CORRIGENDUM - 1 TO TENDER SPECIFICATION BHEL PSSR SCT 1742 - DT: 23.06.2018

TENDER SPECIFICATION BHEL PSSR SCT 1742 - Road formation works up to WBM level inside plant area at BHEL 2X660MW Ennore SEZ STPP, Vayalur BR PO, Minjur Tamilnadu State

TYP. DETAIL OF CONTRACTION JOINT (SPACING @ 3.5M C/C)

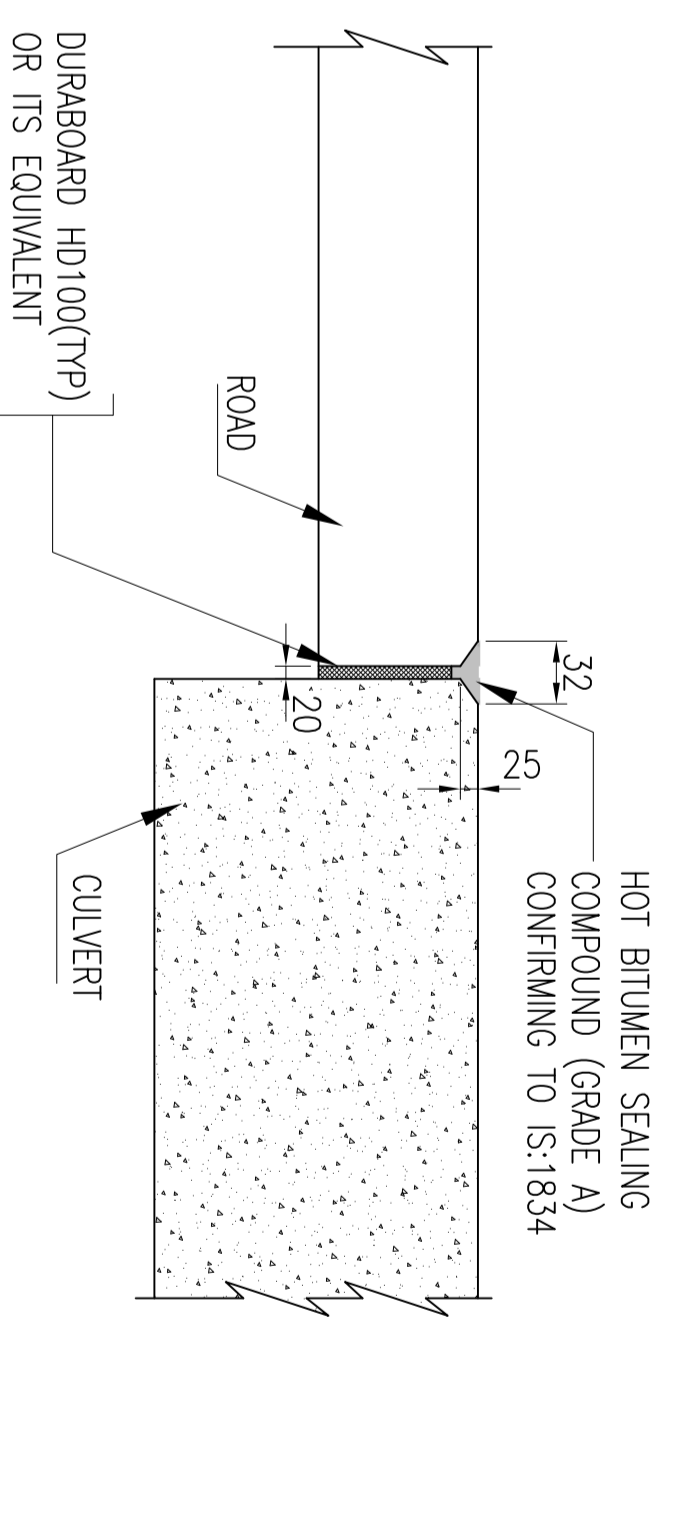
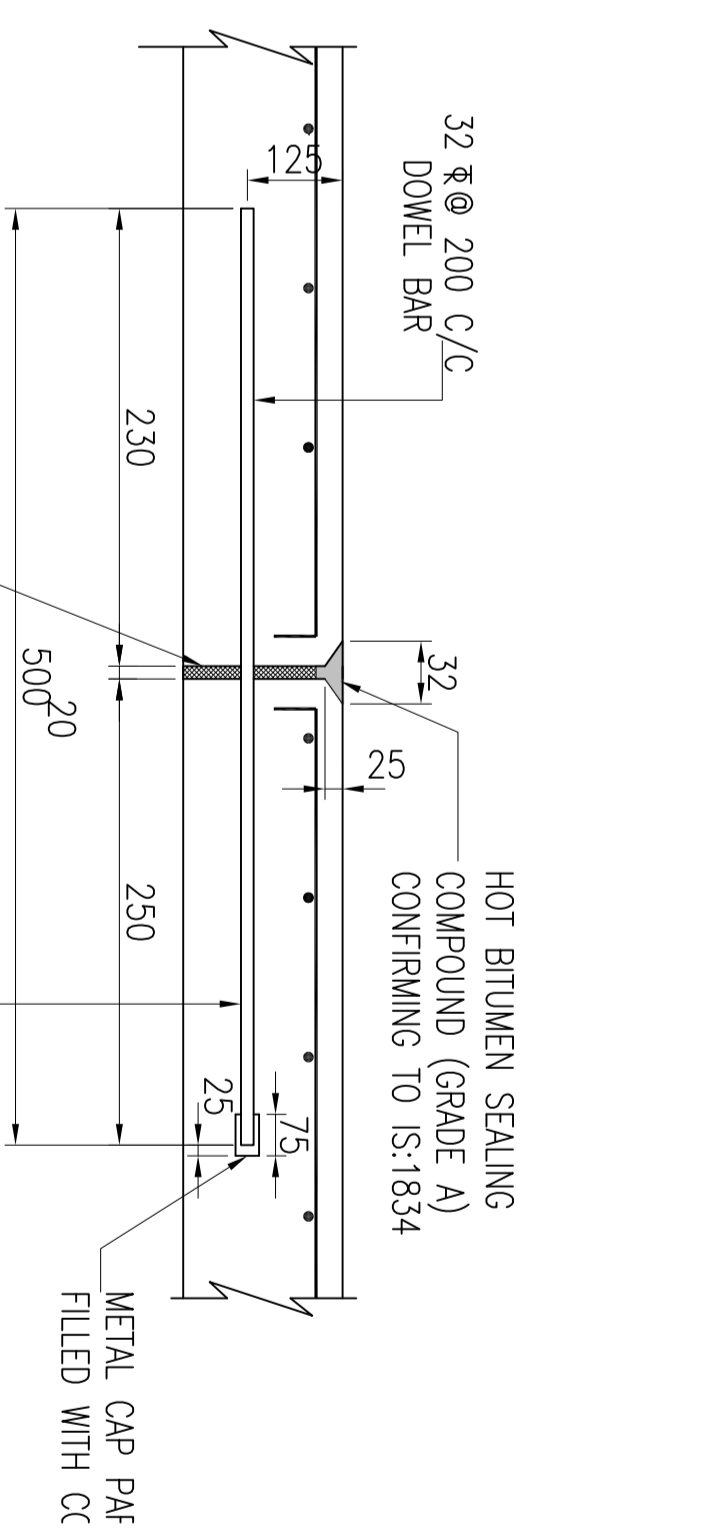
<u>Sl. No.</u>	<u>Bidder's Query</u>	<u>BHEL reply</u>
1	Section drawings for Road works shall please be provided.	Drawing (one page) of 'Plant Road cross section & details' for the said tender attached with this Corrigendum.
